CONSTRUCTION PLANS FOR:

**OWL MARKETPLACE**  
 EL PASO COUNTY, COLORADO

**GENERAL NOTES & ROAD CROSS SECTIONS**

**Know what's below. Call before you dig.**  
 CALL 2-BUSINESS DAYS IN ADVANCE BEFORE YOU DIG, GRADE, OR EXCAVATE FOR THE MARKING OF UNDERGROUND MEMBER UTILITIES.  
 PCD FILE: VR2321

**STORM CULVERT  
DETAILS**

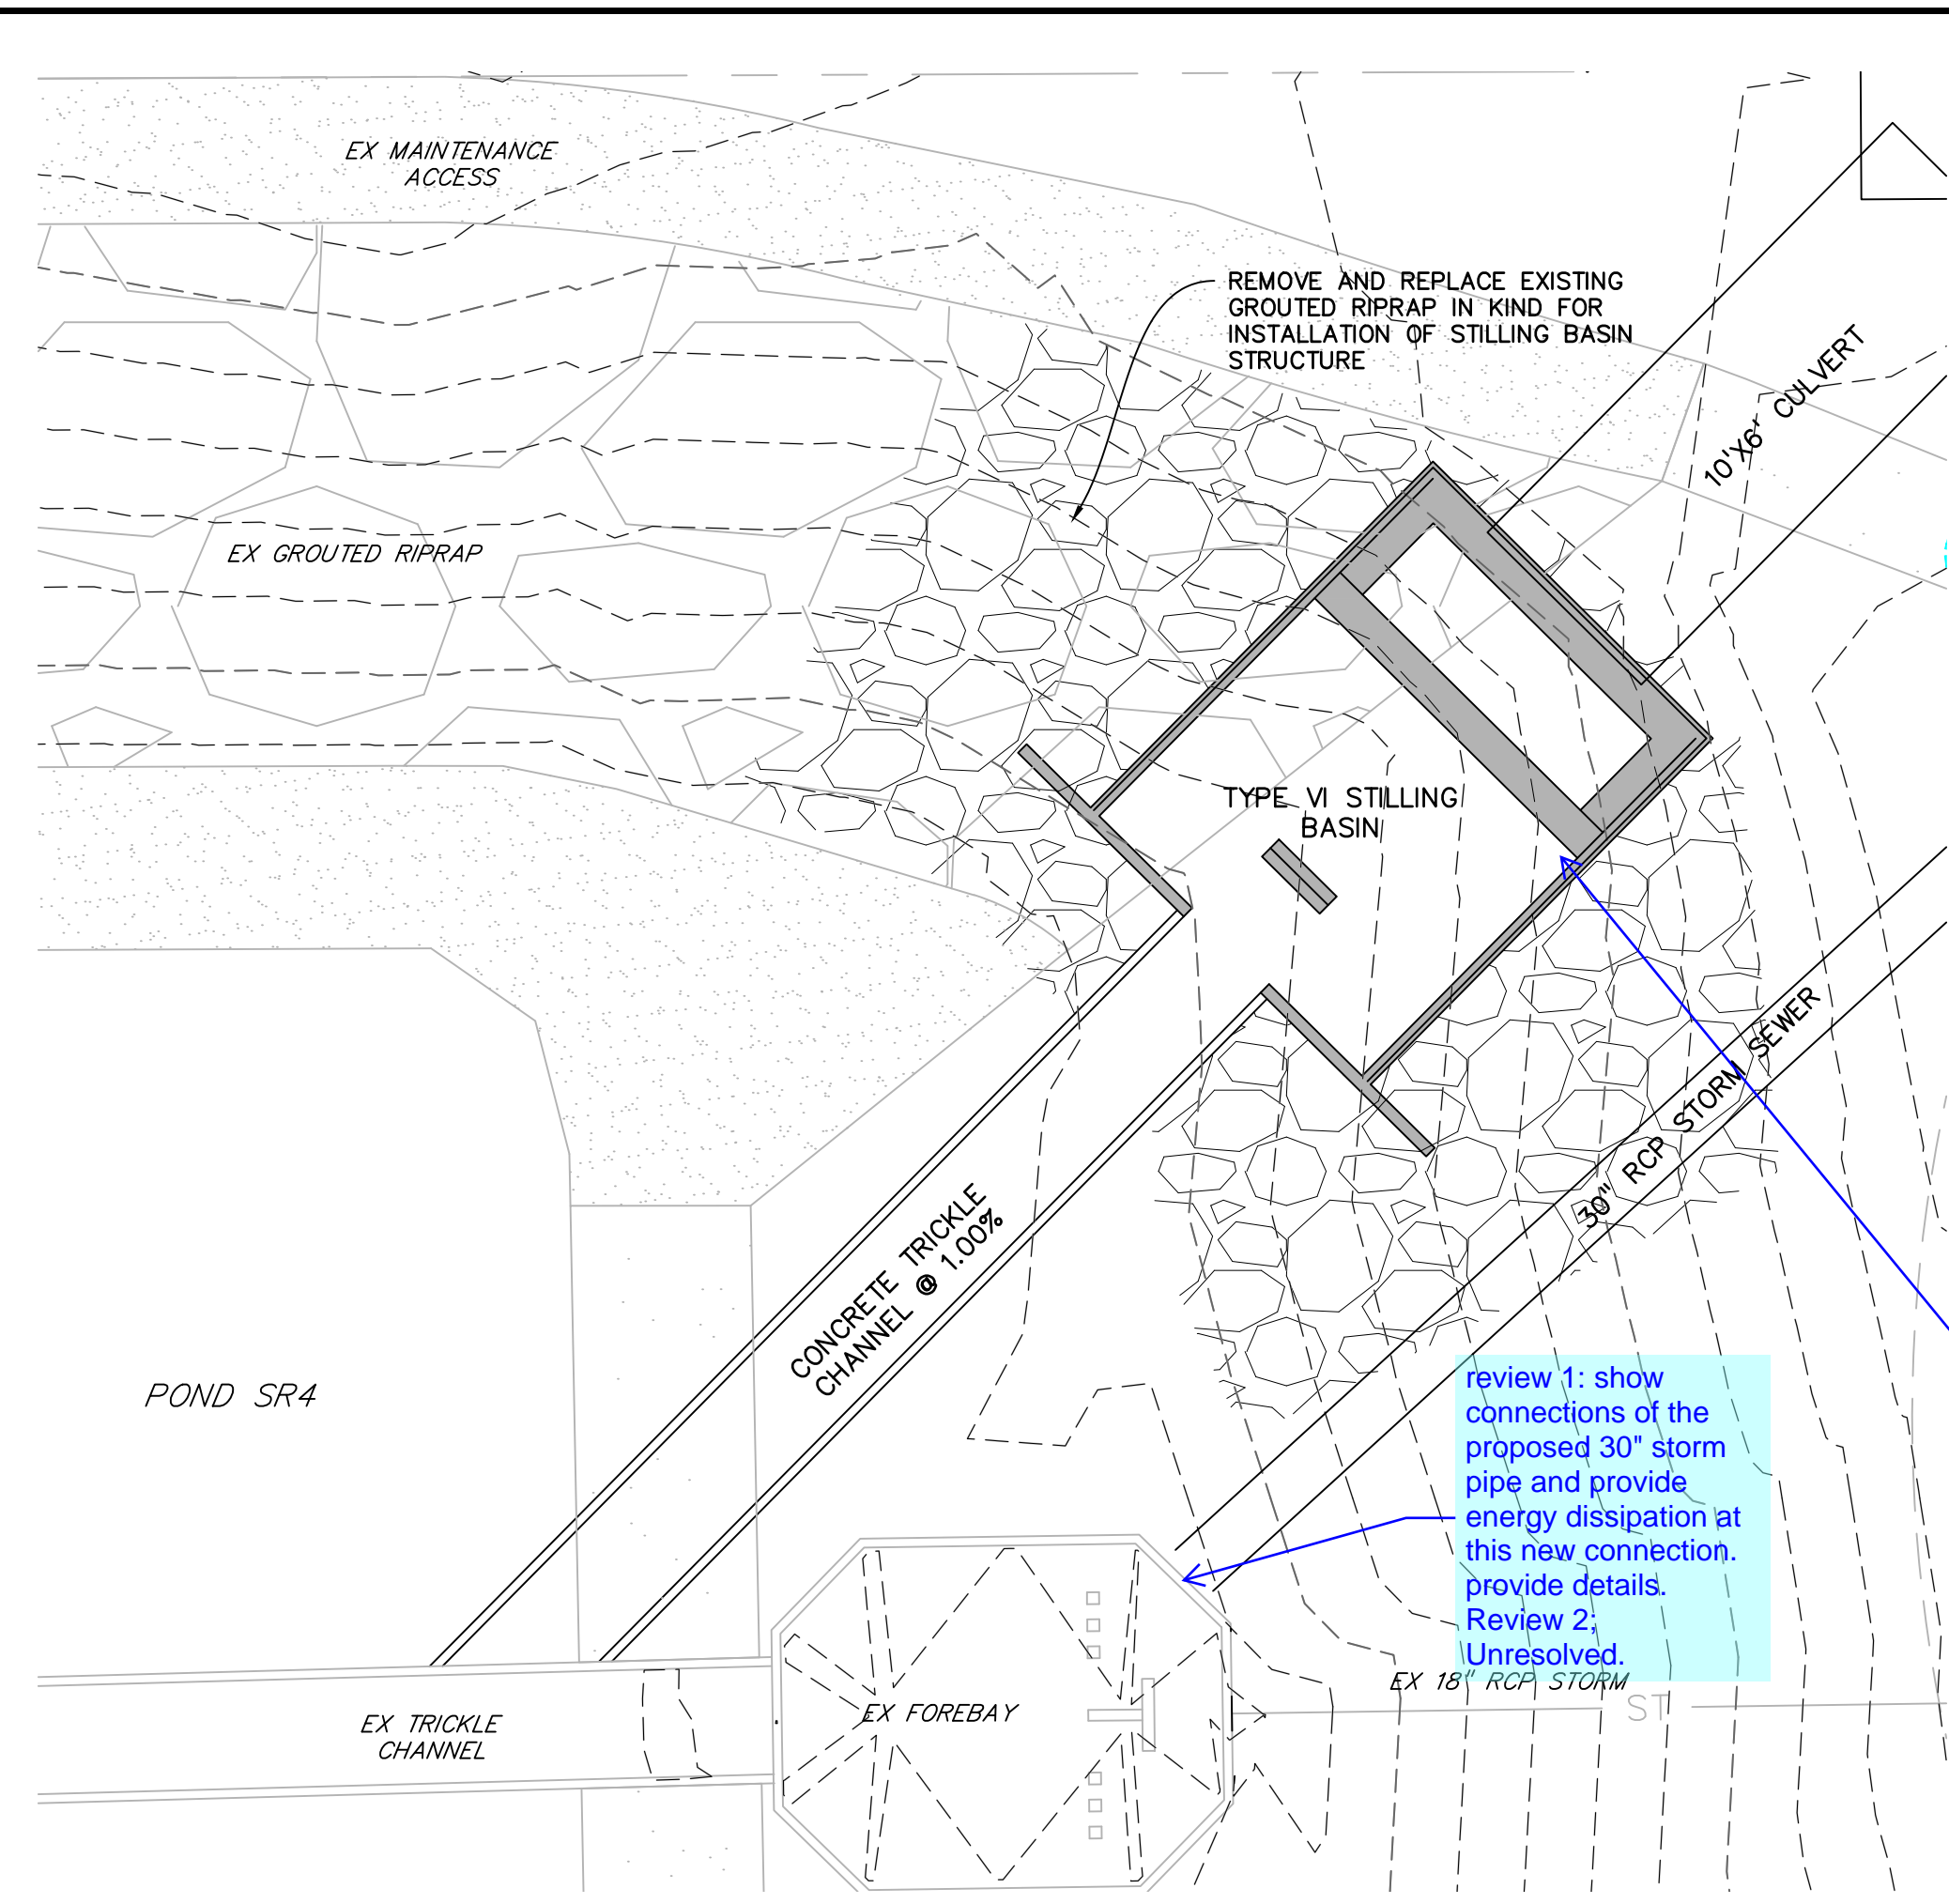
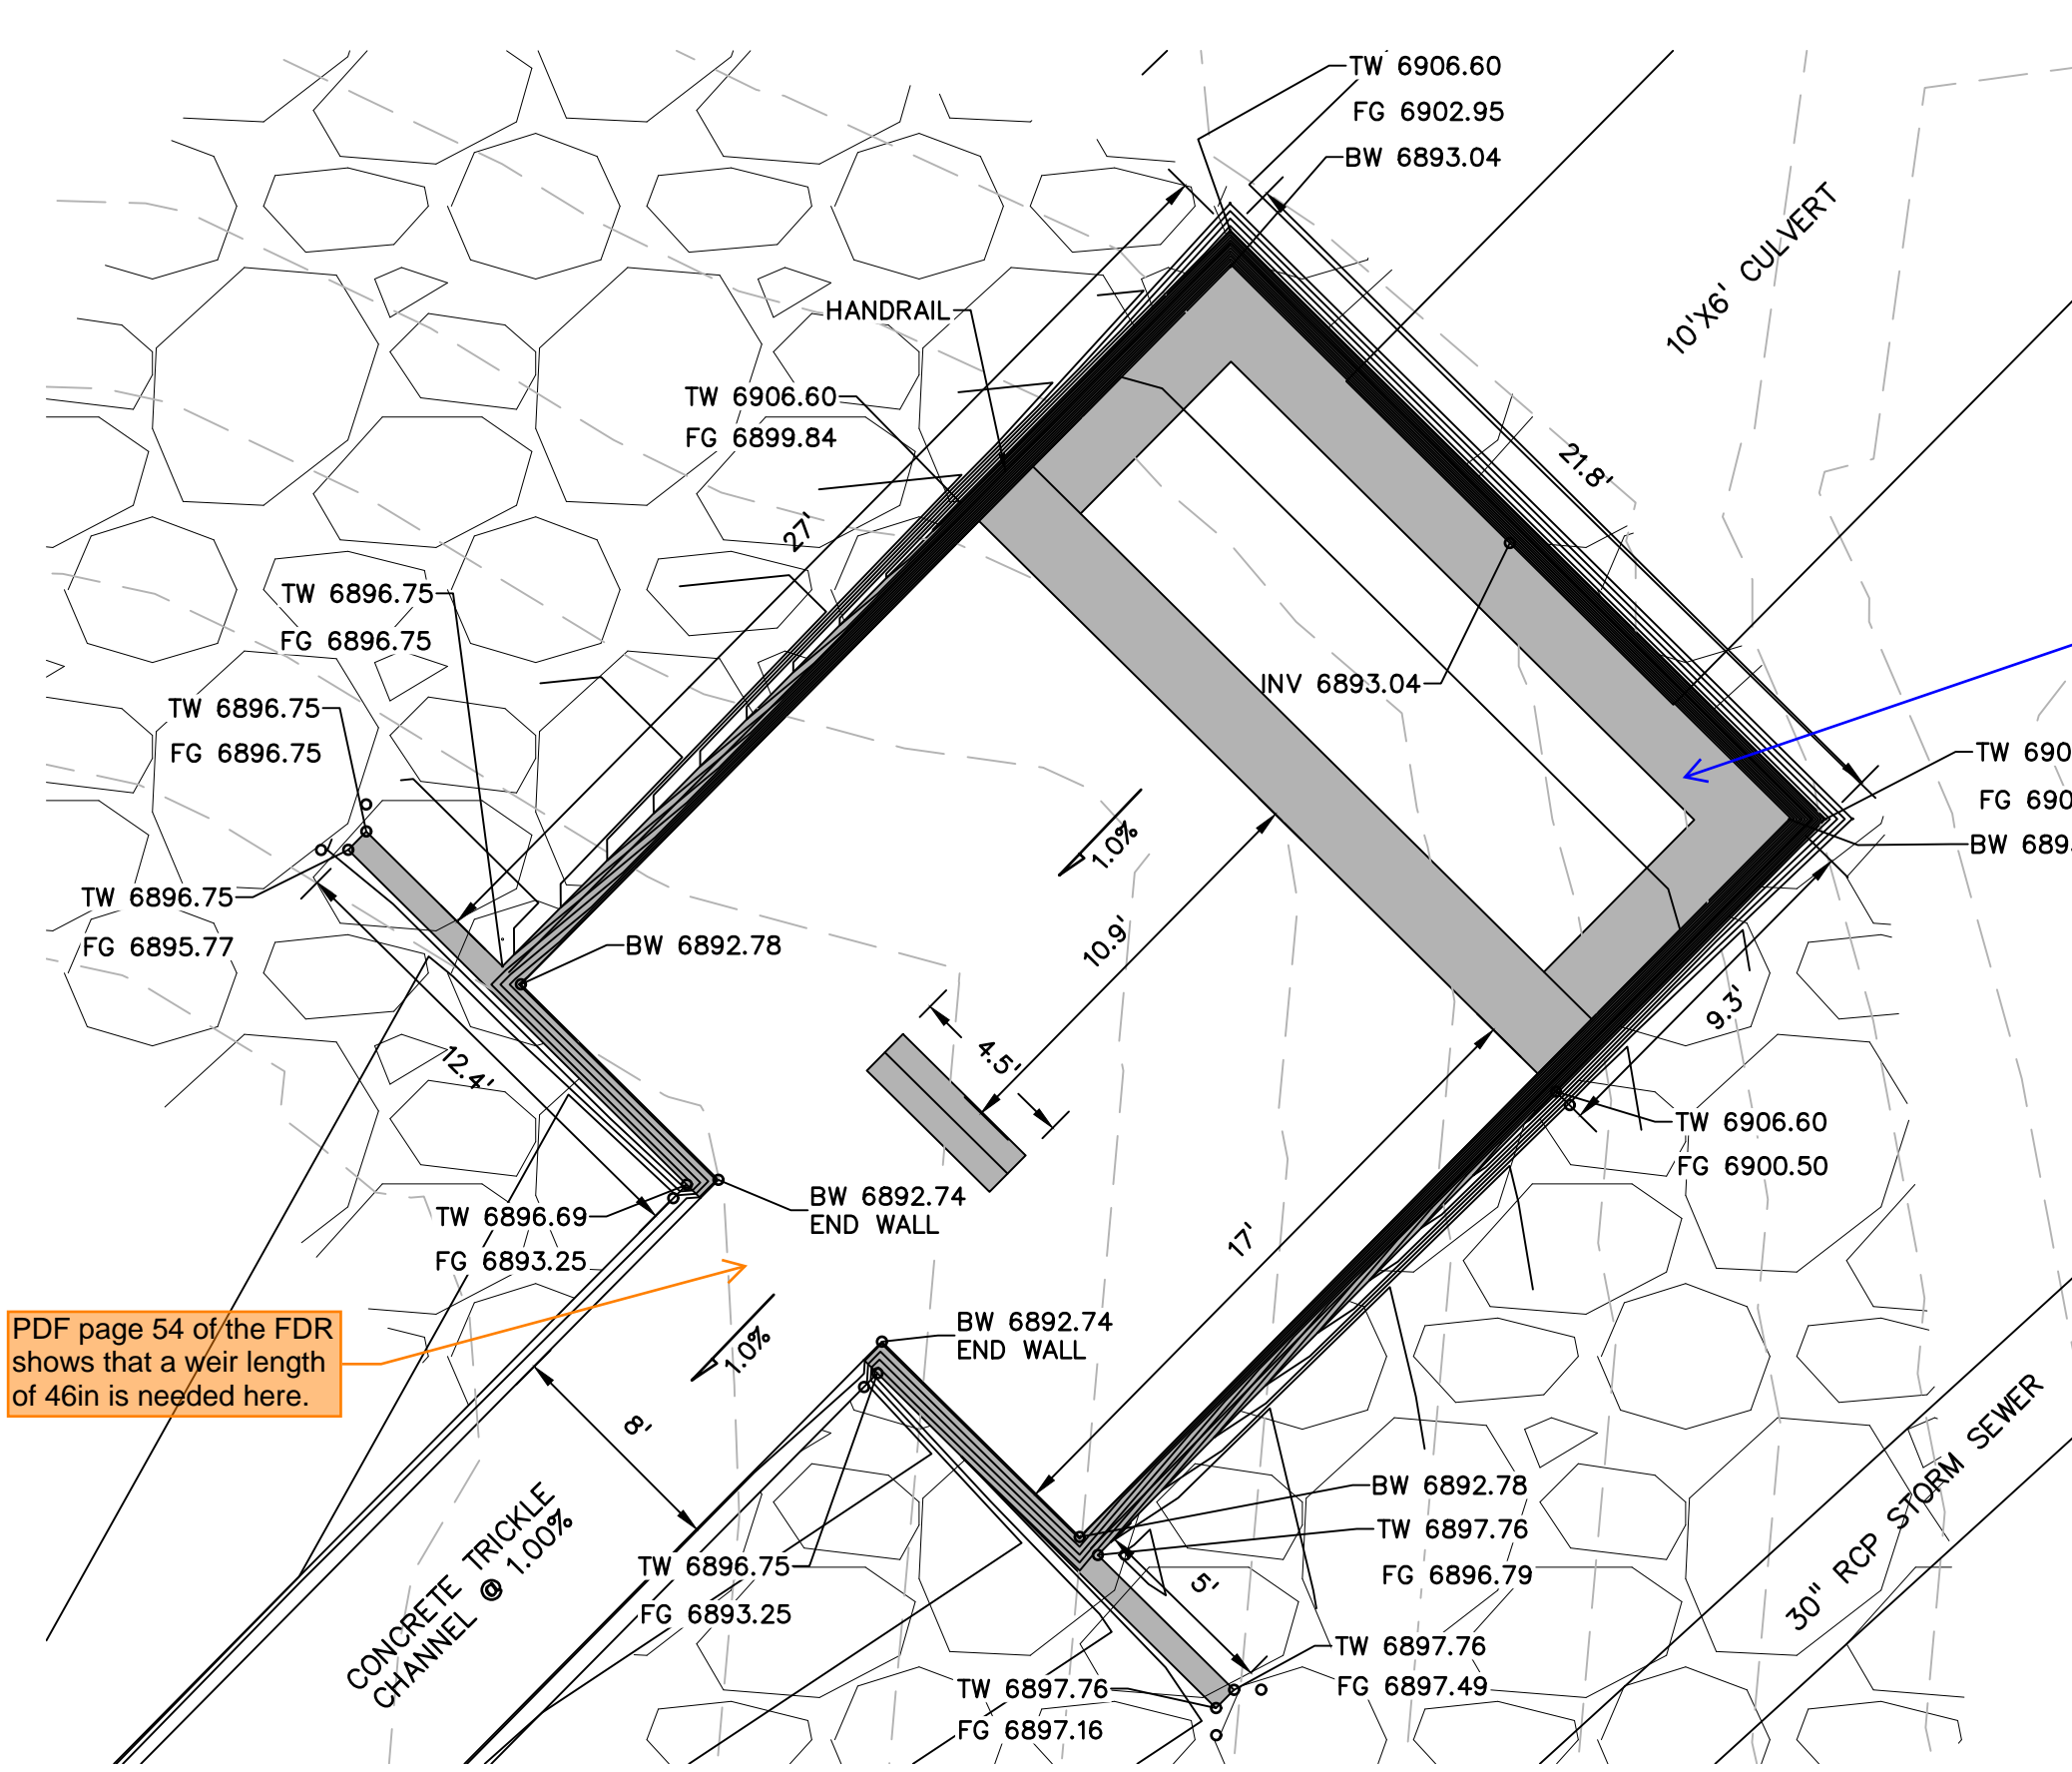
PDF page 54 of the FDR shows that a weir length of 46in is needed here.

Review 1: Provide profile cross-sections and details for safety features  
Review 2: unresolved

review 1: show connections of the proposed 30" storm pipe and provide energy dissipation at this new connection. provide details.  
Review 2: Unresolved.
